# BOULEVARD PLANNING GROUP

**RE: PDS2018-MUP-18-014: INITIAL COMMENTS ON TORREY WIND**

These initial comments are submitted on behalf of the Boulevard Planning Group. We also incorporate by reference our Climate Action Plan comments submitted on 1-16-18, 2-12-18, and our Wind Energy Ordinance comments and Resolution submitted / presented in 2012 and 2013.

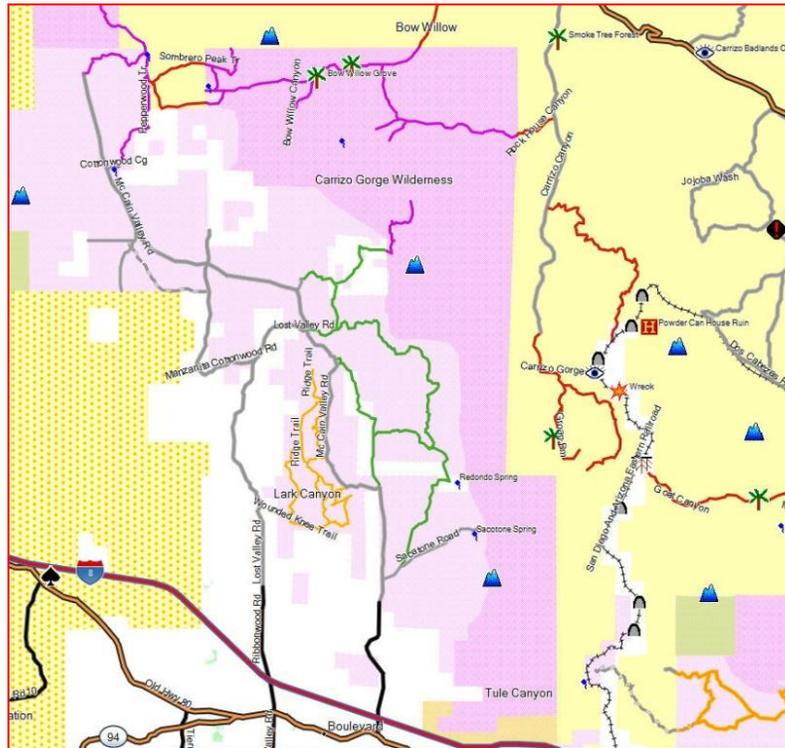
- See comments for IV (7) above regarding Boulevard Trails Map approved in 2009.
- The map below shows some of the trails on adjacent BLM land in the McCain Valley Recreation and Conservation Area. The project site and other private land is shown in yellow dots, north of I-8.
